## **ADDENDUM NUMBER TWO (2)**

**Issuance Date:** December 5, 2025

**Issued by:** Mike Nichols - Ashe Broussard Weinzettle Architects LLP

**Project Name:** Downtown Health Services Center  
Louisiana State University Alexandria  
Alexandria, Louisiana  
**Project Number:** 19-602-23-01, F.19002498, Site Code: 6-40-023  
**Architect Project Number:** ABW: 2023.28 Tipton: 1531.00-23

A103

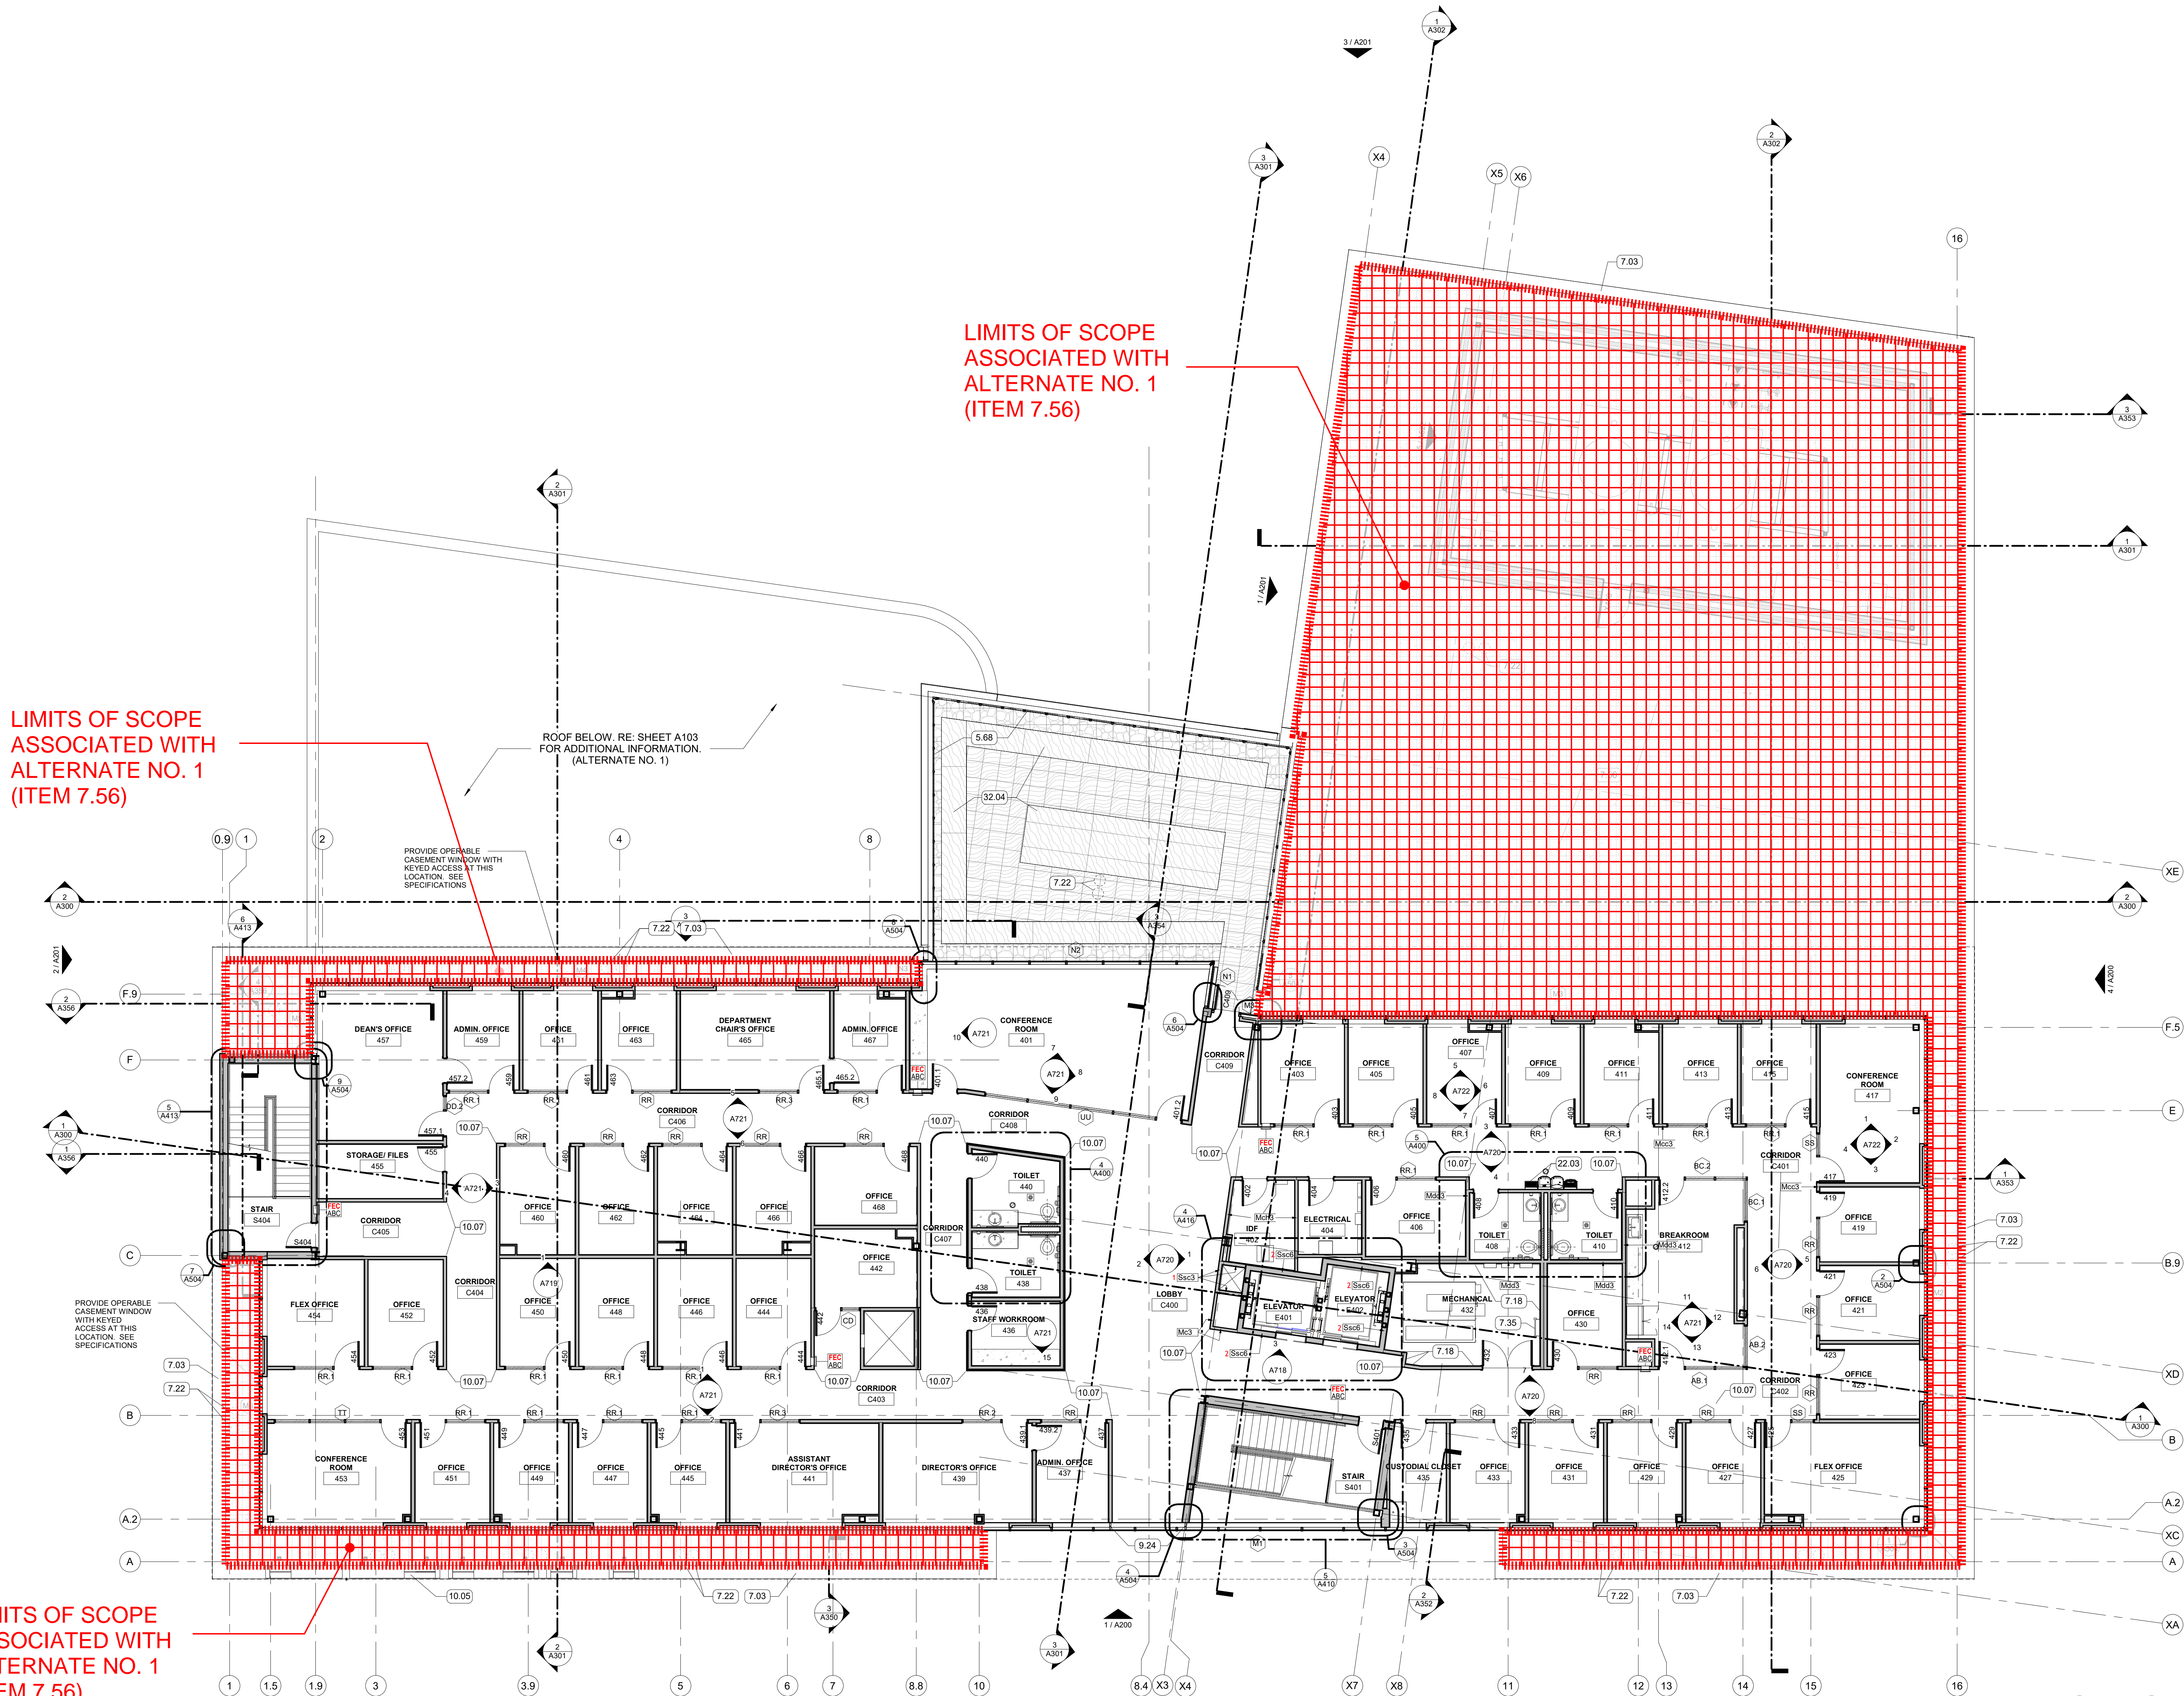
22. RE: A103 Please clarify the extent of the base bid of the 2nd and 3rd floor roof. For the base bid, will the entire roof for these floors be SBS Mod Bit?

6 ENLARGED RESTROOM PLAN - 211A  
1/4" = 1'-0" | RE:1/A102

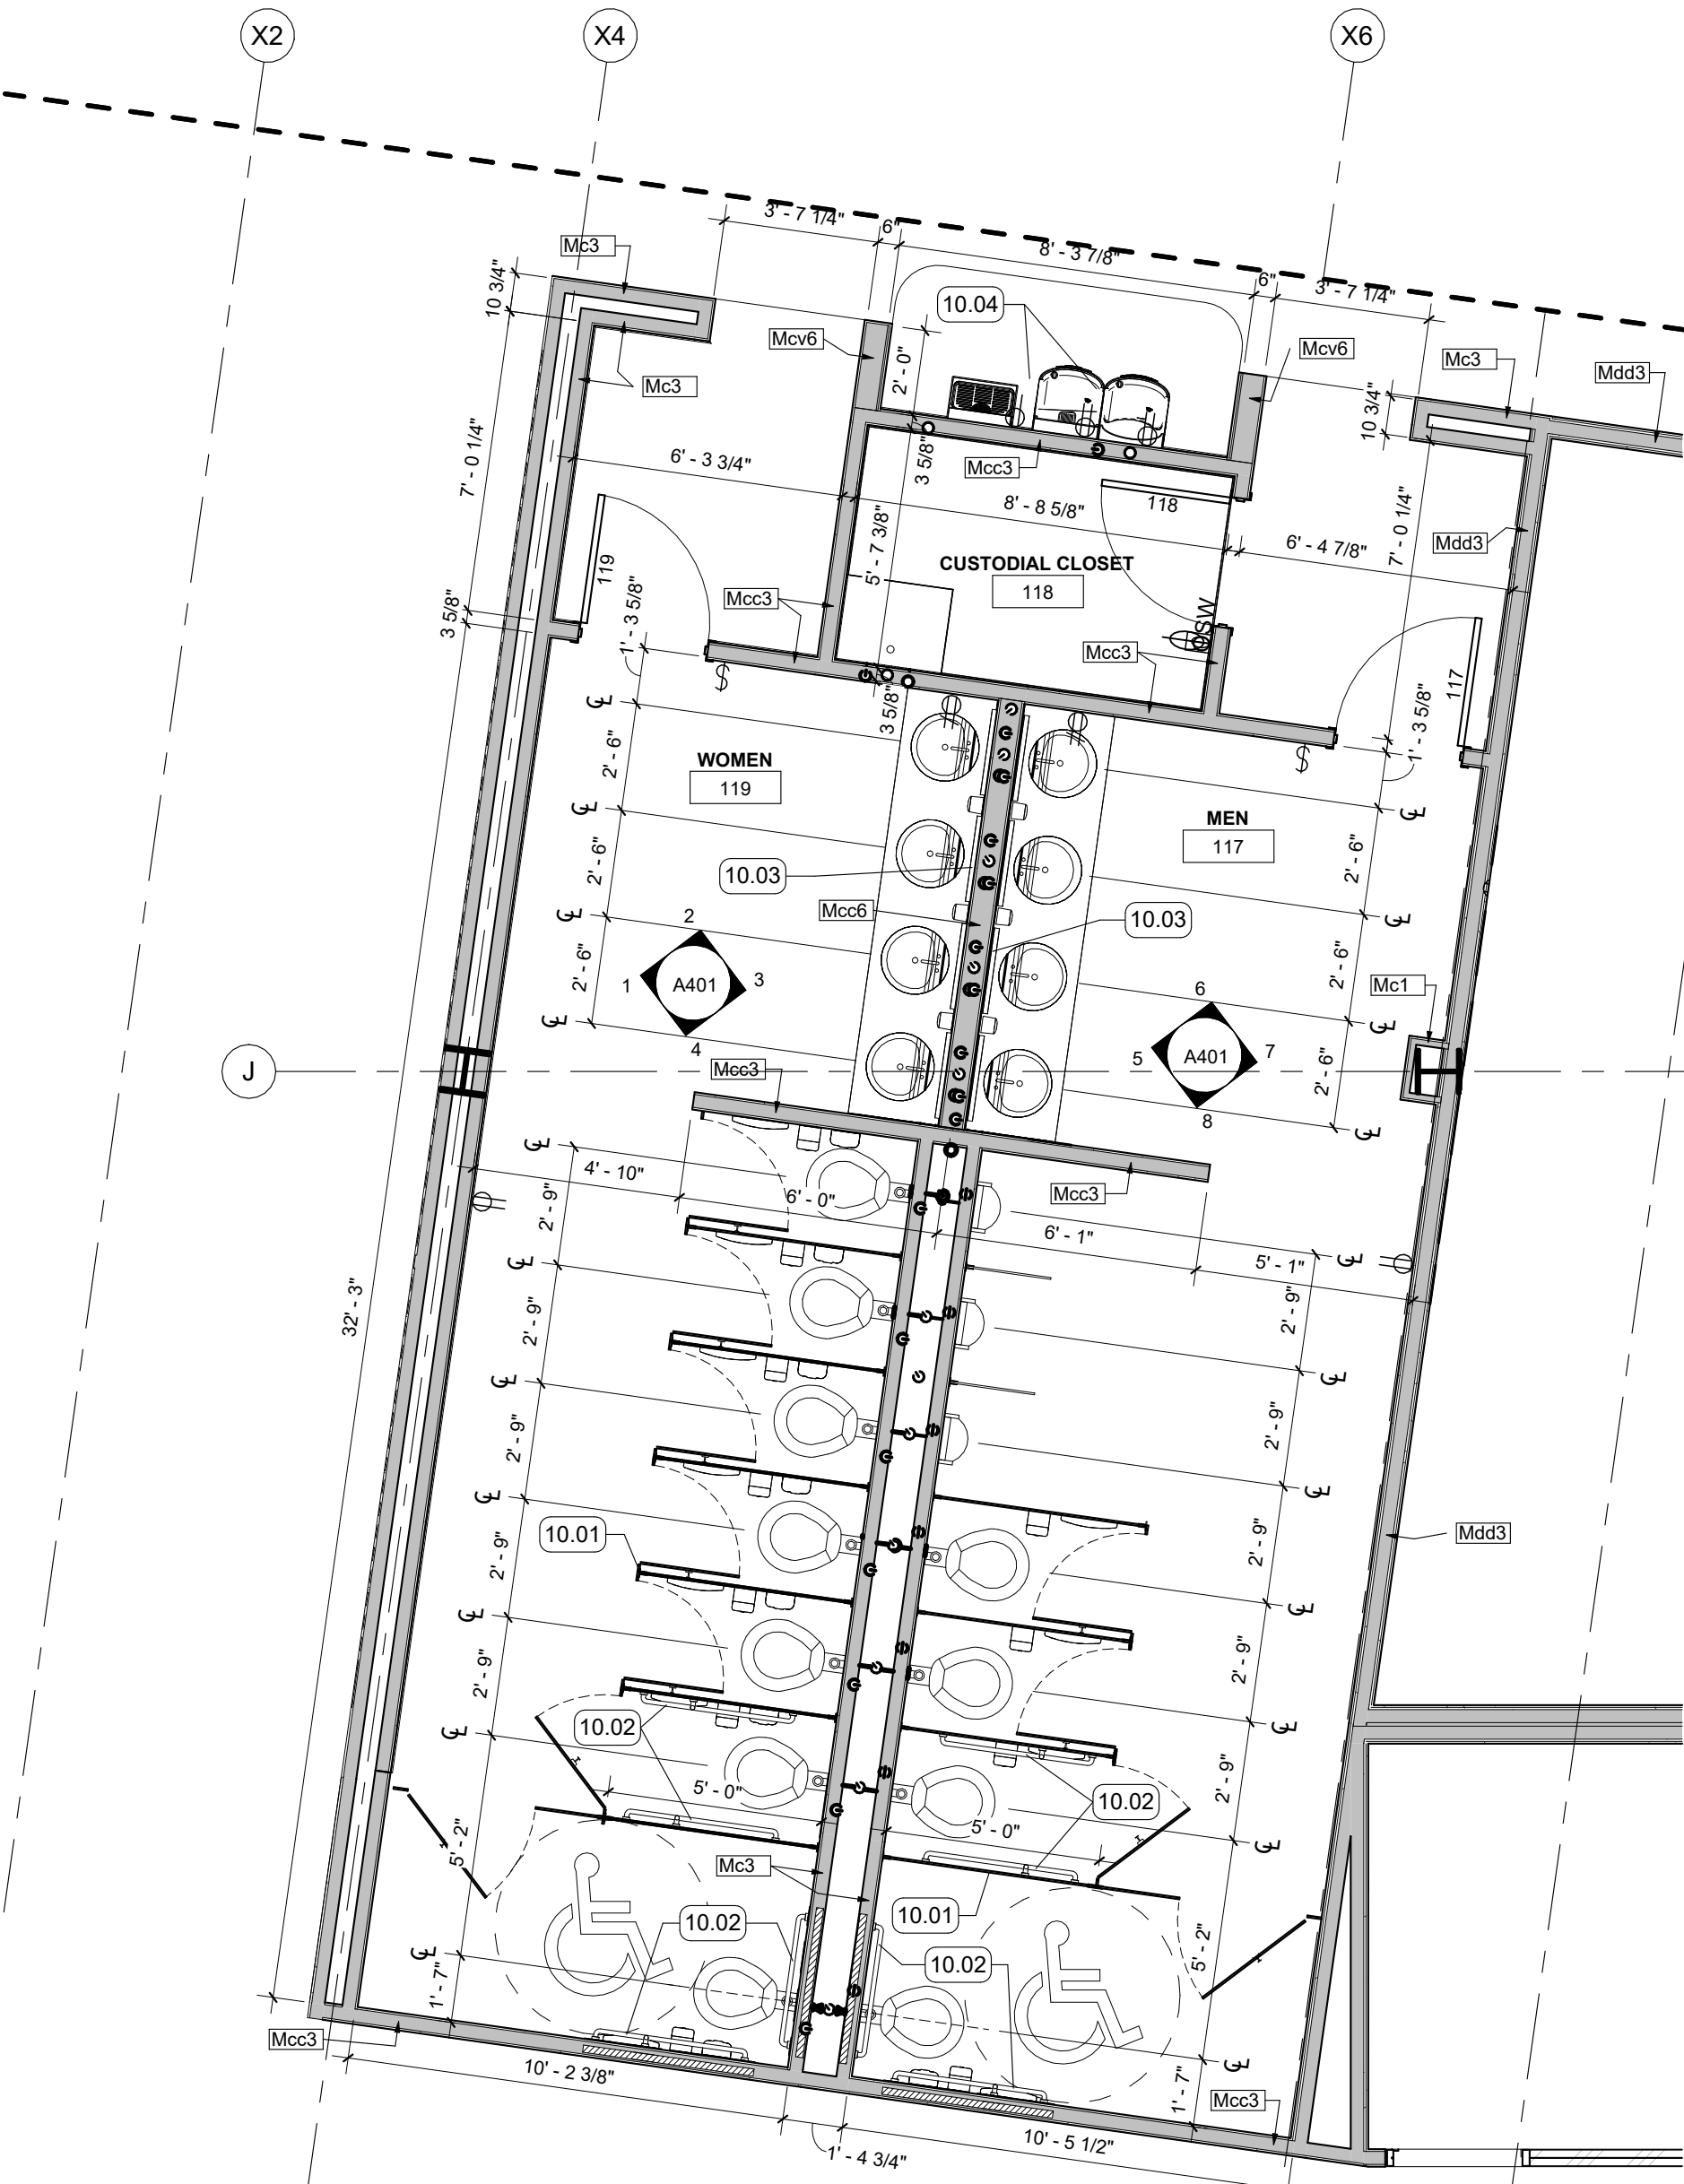
RESPONSE: Reception Desk to be provided as furniture. Utilities to be provided as shown for future connection.
17. RE: 6/A400 Please confirm countertop type in restroom 211A.

RESPONSE: Countertop to be ES-02 to match other single hold Toilets. Refer to Detail 7/A400
18. RE: 05 12 00 Please clarify if AISC certifications for steel fabrication and erection is required.
